# Statement of Compliance Access for People with a Disability

# **Proposed Mixed Use Development**

91-93 McIntosh Rd Narraweena

**Report Type:** Statement of Compliance - BCA Access Provisions

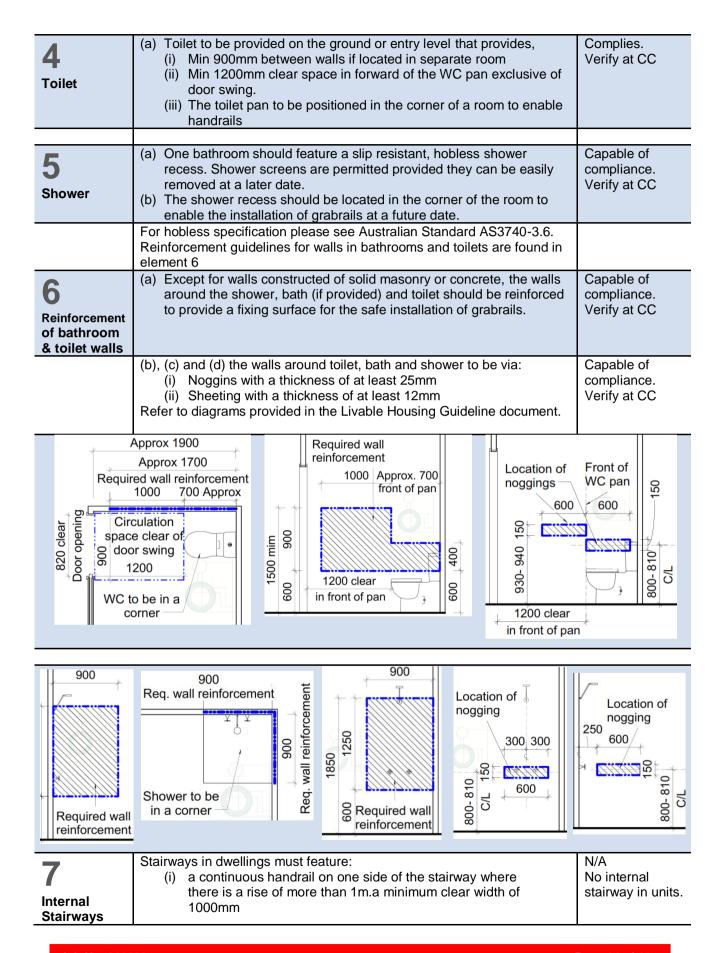
Since 1 of the units (**Unit 8**) already comply with the Adaptable unit requirements, these units are also capable of satisfying the intent of Silver level of Livable Housing Guidelines as noted in the table below.
